SECTION HA

MODIFICATION NOTICE:

REFRIGERANT SYSTEM PROTECTION

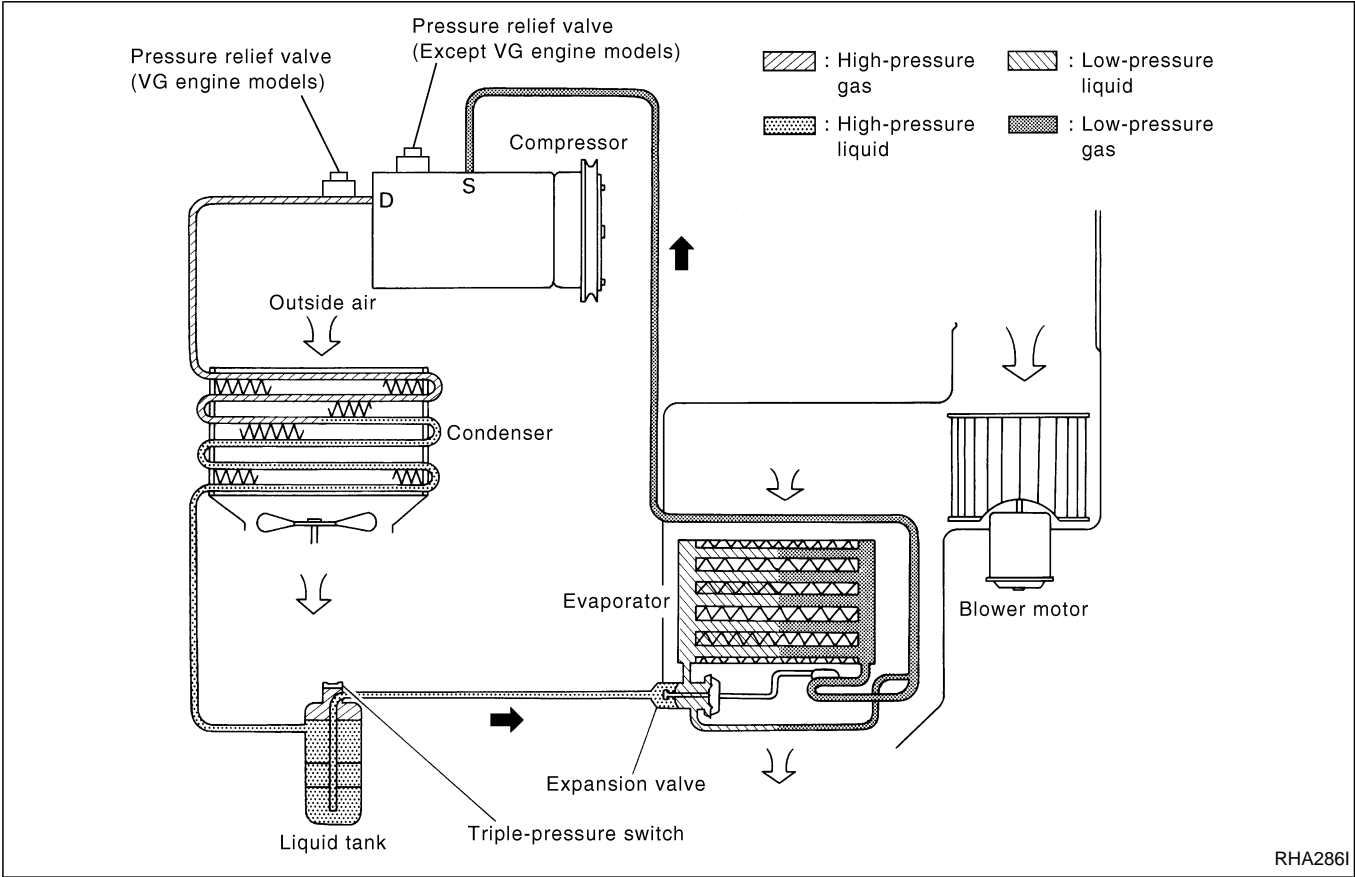
- Compressor has been changed. (KA, TD and QD engine models)
- Refrigerant amount has been changed.
- A/C cycle for VG33 engine models has been added.
- Fusible plug attached to liquid tank has been deleted.
- Pressure relief valve has been added to high-pressure flexible hose. (VG engine models)
- Pressure relief valve has been added to compressor. (Except VG engine models)
- Wiring diagrams have been changed.
- Thermo control amp. of auto A/C has been abolished and trouble diagnosis of magnet clutch has been changed. (For Europe)
- Pressure relief valve has been added to compressor. (KA24DE and YD25DDT engine models for Europe)
- Refrigerant amount has been changed. (YD25DDT engine models for Europe) Refer to SDS.

The refrigerant system is also protected by a pressure relief valve located on the compressor (Except VG engine models) or high-pressure flexible hose (VG engine models). When the pressure of refrigerant in the system increases to an unusual level [more than 3,727 kPa (37.3 bar, 38 kg/cm², 540 psi)], the release port on the pressure relief valve automatically opens and releases refrigerant into the atmosphere.
